Product Change Notification / ASER-27FWWD026

CCB 4713 Final Notice: Qualification of MMT as a new assembly site for TC500CPE, TC500ACPE and TC500CPE519 catalog part numbers (CPN) available in 16L PDIP (.300in) package.

**CCB 4713**  
**Pre and Post Change Summary**  
**PCN #: ASER-27FWWD026**

# Lead Frame Comparison

## Pre Change

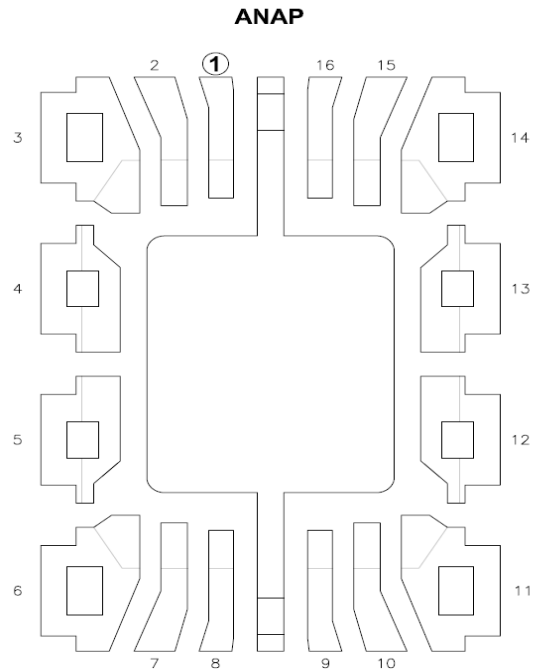
Lead frame paddle size

140 x 170 mils

## Post Change

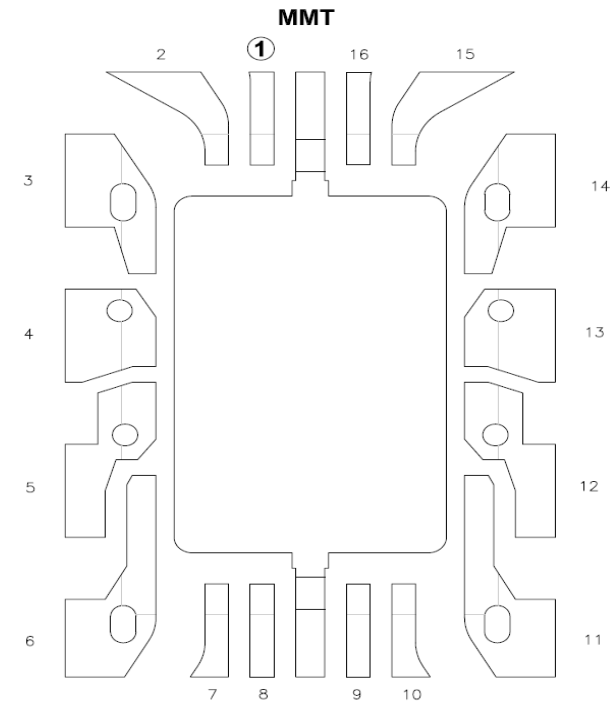
Lead frame paddle size

150 x 230 mils
